# UNITED STATES PATENT AND TRADEMARK OFFICE

APPLICATION NO.	FILING DATE	FIRST NAMED INVENTOR	ATTORNEY DOCKET NO.	CONFIRMATION NO.
10/621,317	07/18/2003	Ashvin D. Desai	87344.1524	2539

## Office Action Summary

FIG. 4

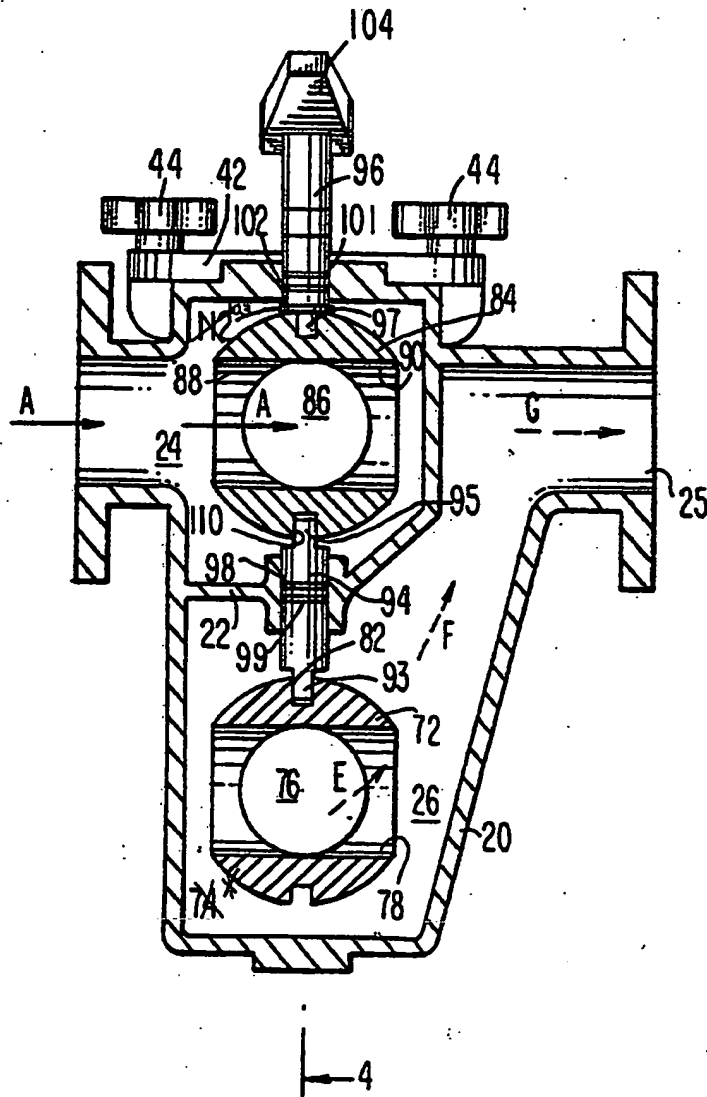
The drawing corrections to FIG. 4 has not been approved for the reasons set forth below.

The lead line for element 28 is incorrect in FIG. 4 (the lead line should be redrawn so that it points out the seat adjacent the entry port 36);

The lead line for element 116 is incorrect in FIG. 4 (the lead line should be redrawn so as to point out the seat adjacent exit port 38).
